**DA NO:** DA-2021/123/A

**ADDRESS:** 46, 48 & 48A EASTERN VALLEY WAY, NORTHBRIDGE

**PROPOSAL:** INTERNAL AND EXTERNAL CHANGES TO APPROVED DEVELOPMENT INCLUDING MODIFICATIONS TO RL'S, GROSS FLOOR AREA, LANDSCAPING AND ASSOCIATED WORKS .

**REPORT DATE:** 2 JULY 2024

Figure 1 Comparison: Front Elevation

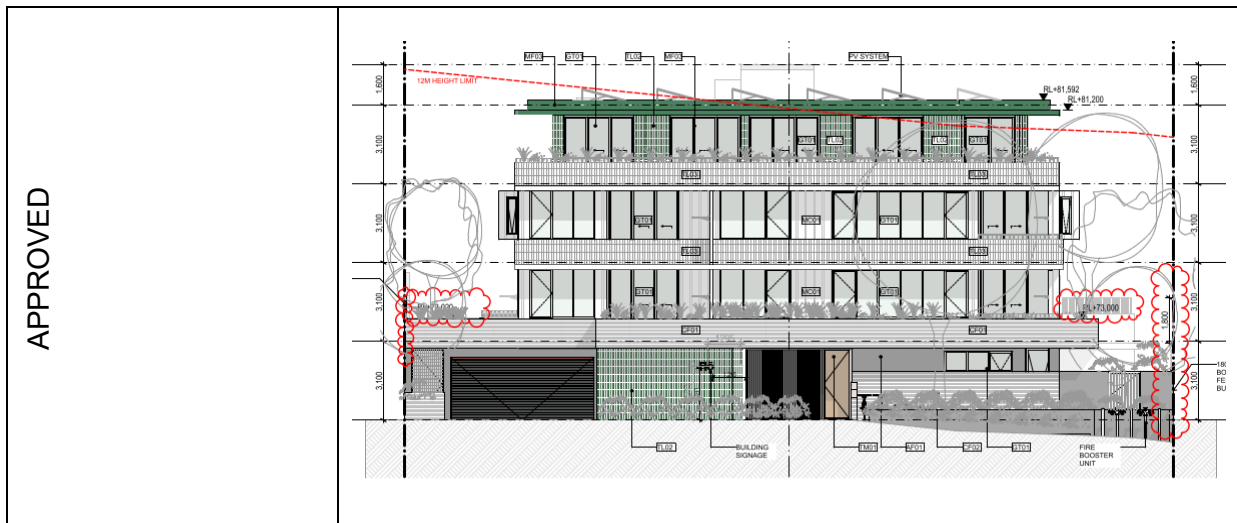
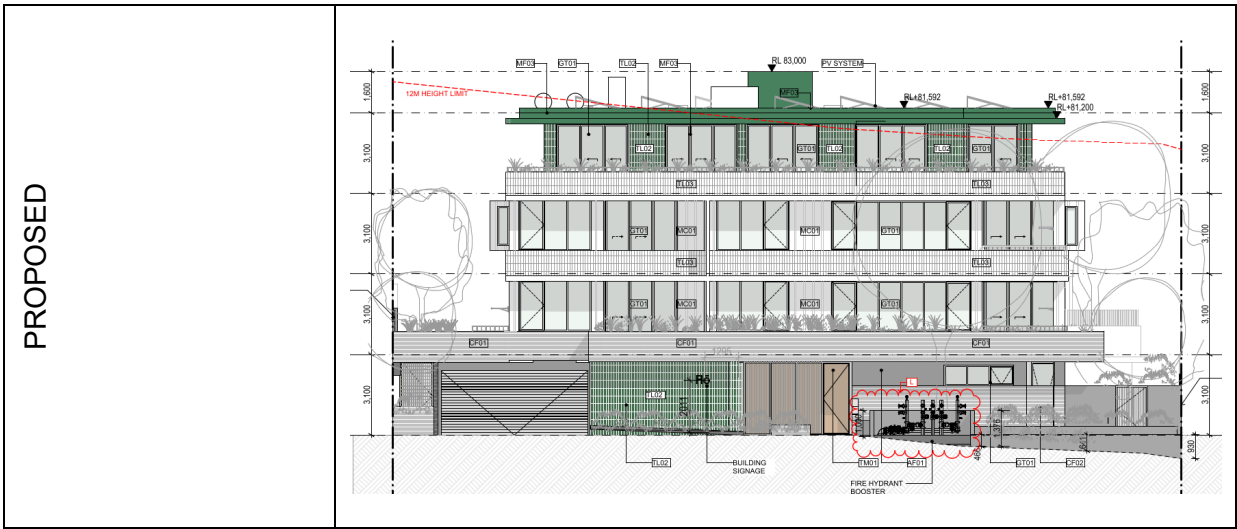
Figure 1 provides a comparison of the approved and proposed front elevation. The main difference is the relocation of the water hydrant to the centre of the site.

Figure 2 Comparison: Southern Side Elevation

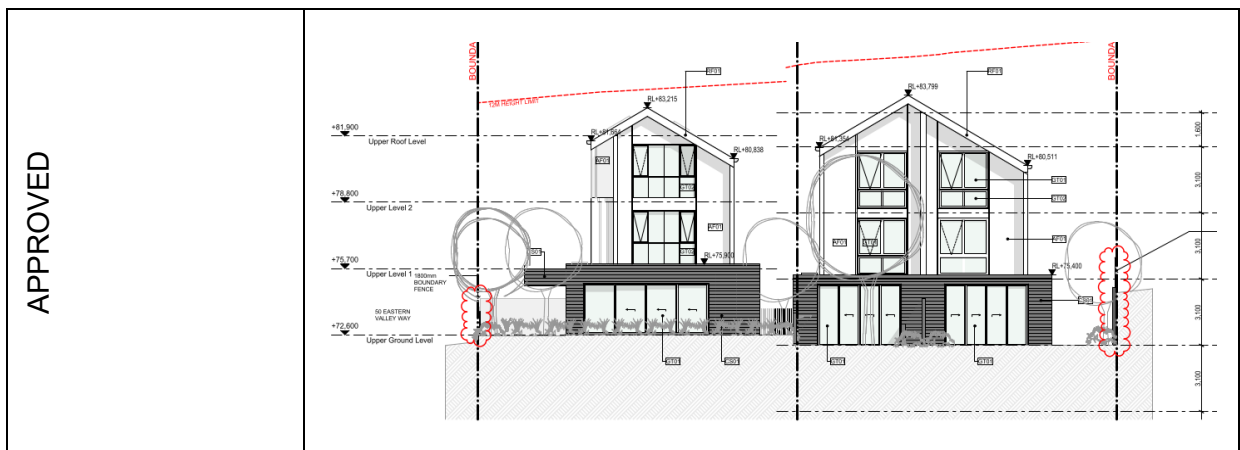
Figure 2 provides a comparison of the approved and proposed southern side elevation. The changes are an increase in the floor and eave levels of the townhouses.

Figure 3 Comparison: Rear Elevation

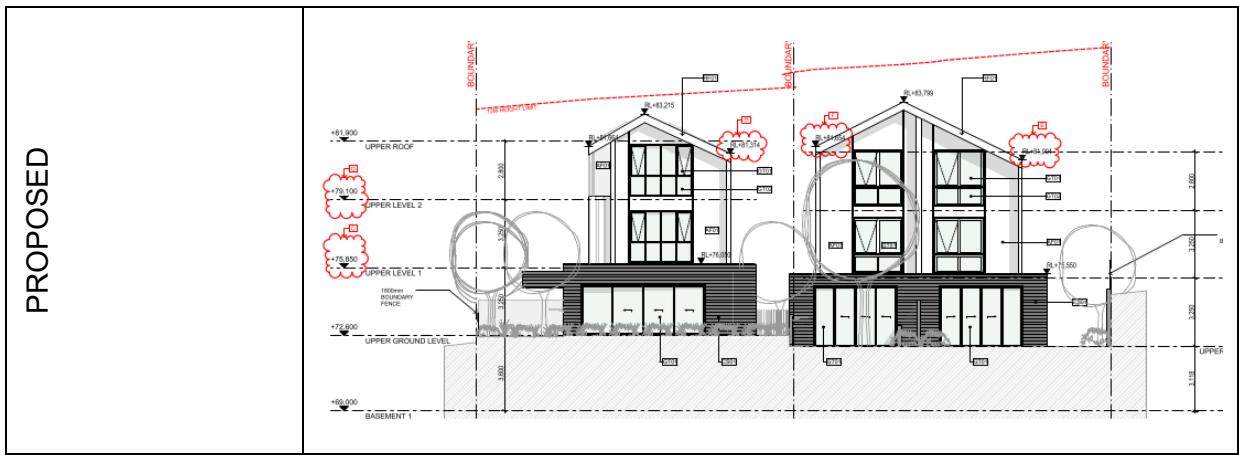
Figure 3 shows a comparison of the approved and proposed rear elevation. The increased floor and eave heights have been offset by reducing the pitch of the roof to maintain the same overall approved building heights of the townhouses.

Figure 4 Comparison Front Setback Landscaping

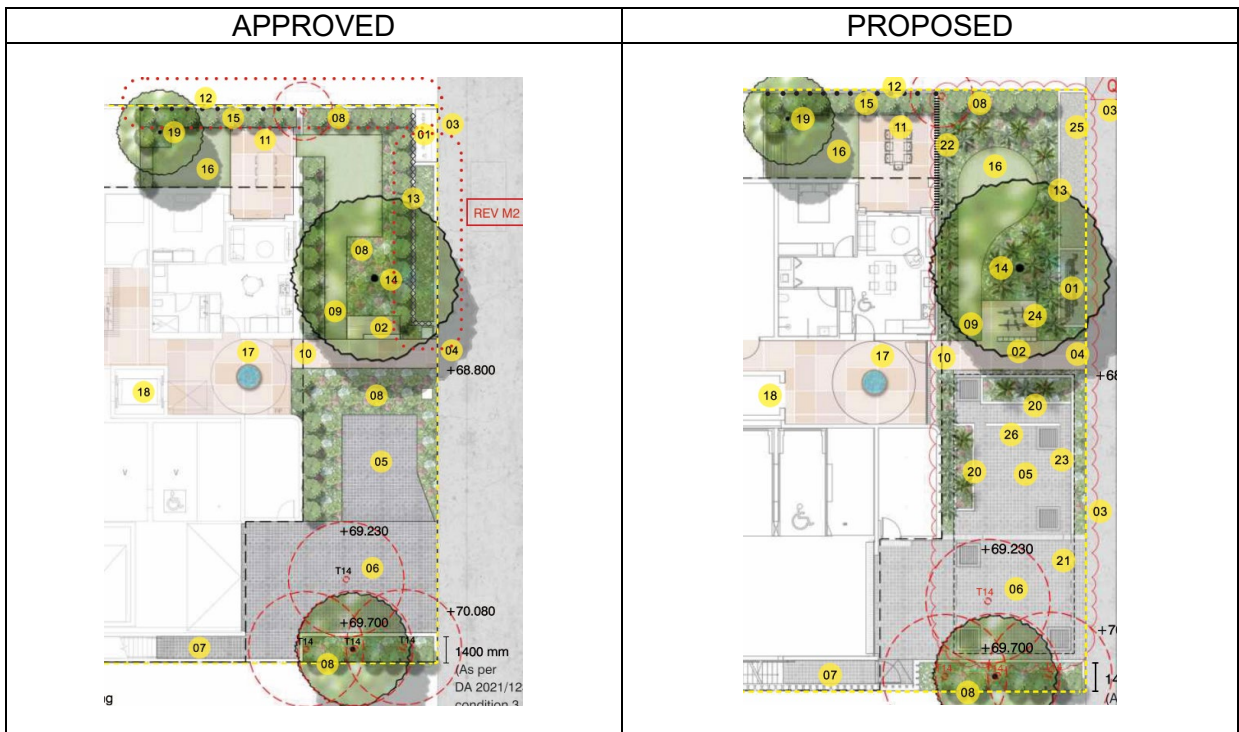
Figure 4 provides a comparison of the approved and proposed Landscape Plan for the front setback area. The approved plan did not reflect the impact of the OSD tank beneath the loading dock and the inadequate soil depth available without raised planter beds. The proposed plan provides for raised planter beds with losses to the landscaped area to provide for OSD inspection grates and pedestrian access to the front entry to the RFB.

Figure 5 Comparison Landscape Area and Deep Soil Zone

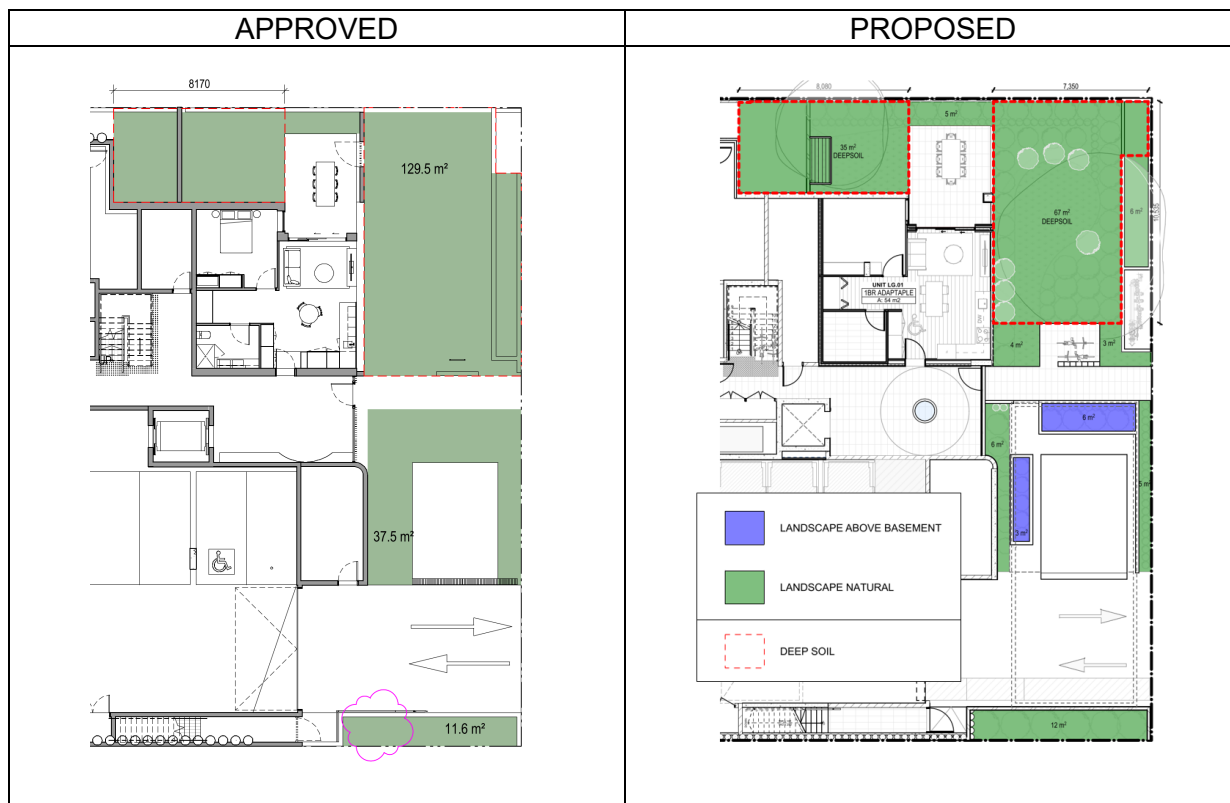
Figure 5 provides a comparison of the approved and proposed Landscaped Areas within the front setback area.

Close analysis of the approved plans revealed that the actual available area of deep soil zone was less than the area notated on the plans. The actual area was 269m<sup>2</sup> (not 282m<sup>2</sup>). The actual proposed reduction in deep soil zone is 22m<sup>2</sup> to 247m<sup>2</sup>, being a reduction from 13.1% to 12.0% of the site area.

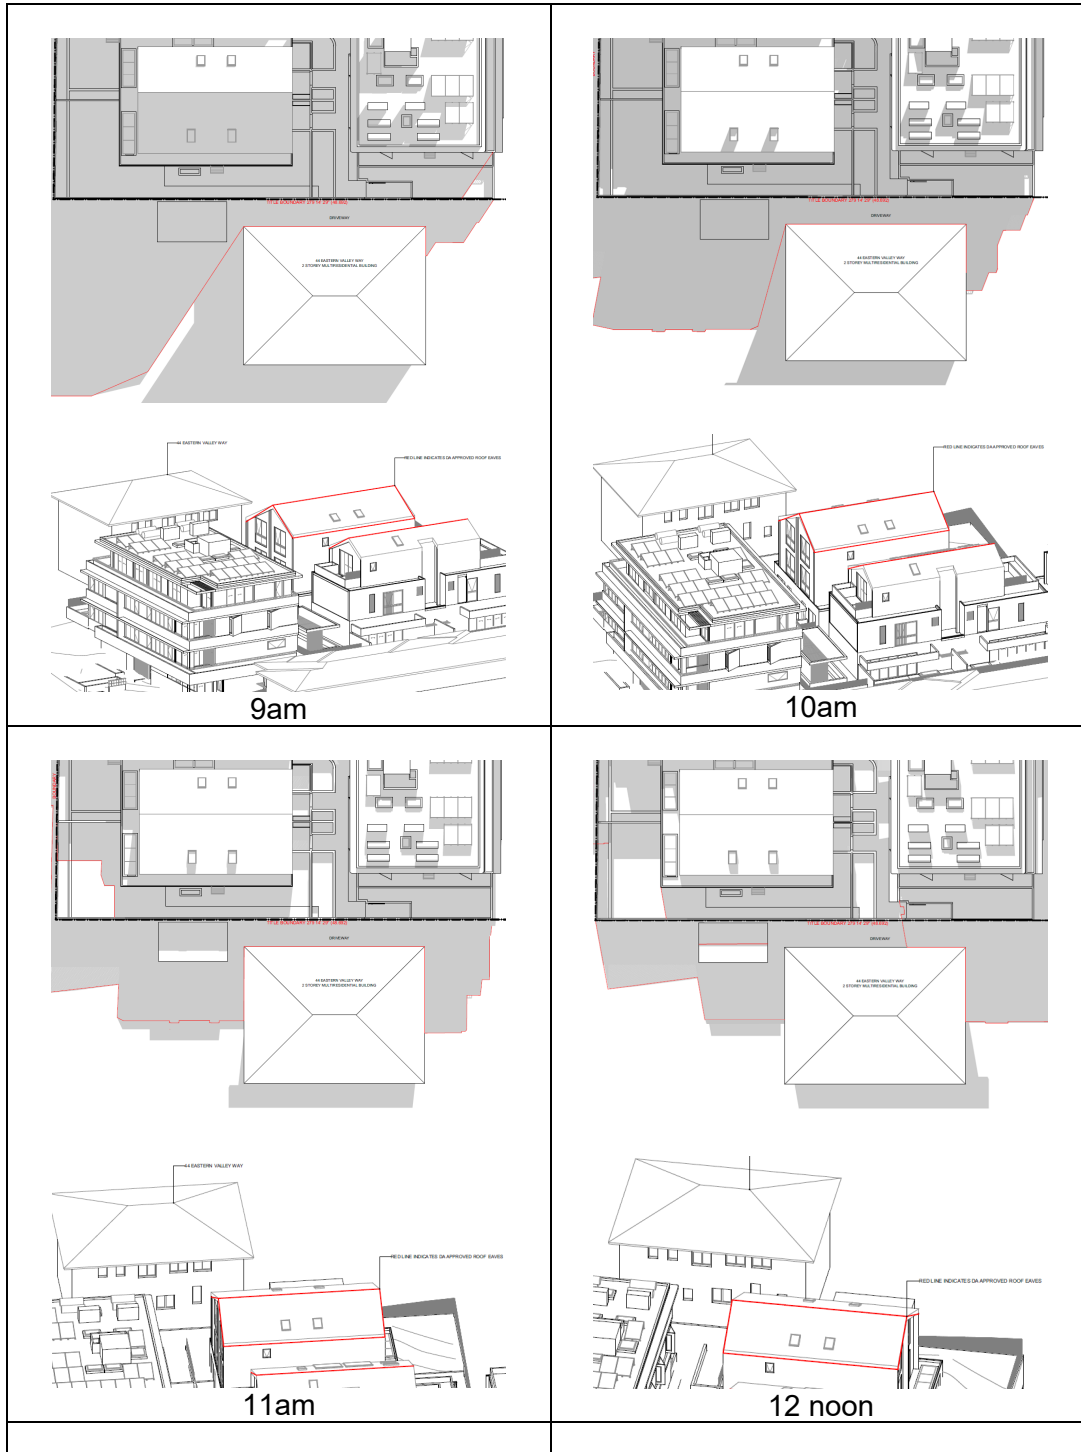
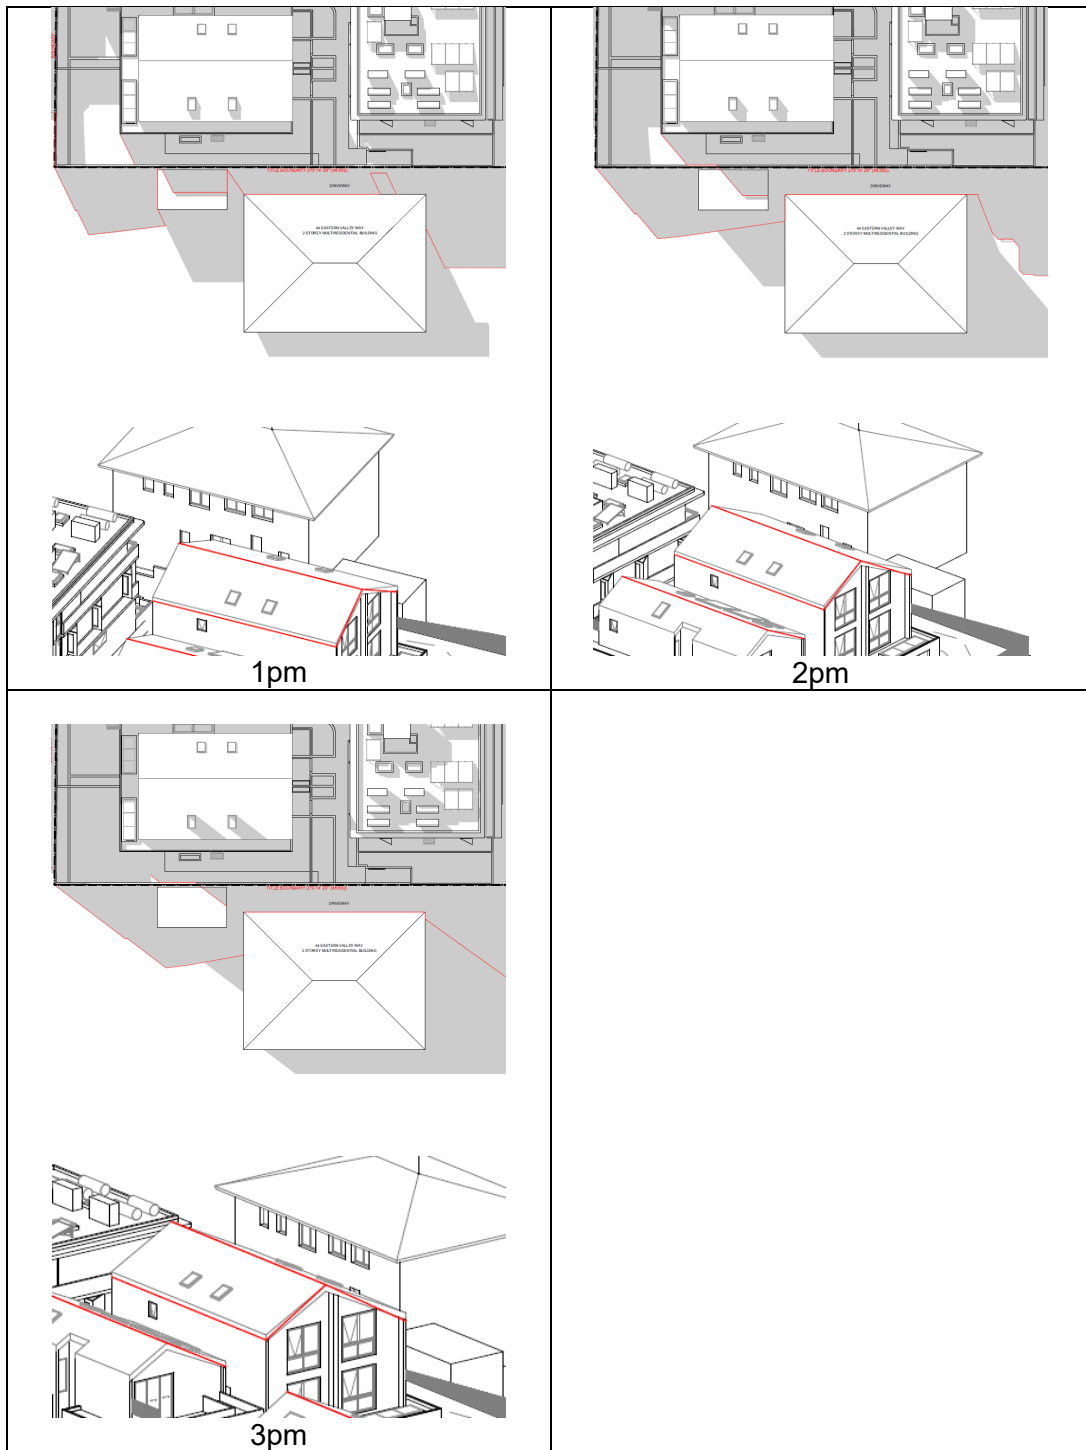
Figure 6 provides a comparison between the overshadowing of the approved plans (red outline) and the proposed plans (grey shading).

There is a minor increase in the extent of overshadowing of 44 Eastern Valley Way, as a result of the increased height of wall/eaves to TH01. The northern side setback of 44 Eastern Valley Way contains a driveway access and does not provide functional private open space.

The northern side elevation of 44 Eastern Valley Way will be subject to minor additional overshadowing from about noon. The increase is marginal and not considered to be consequential for the assessment of the modification.
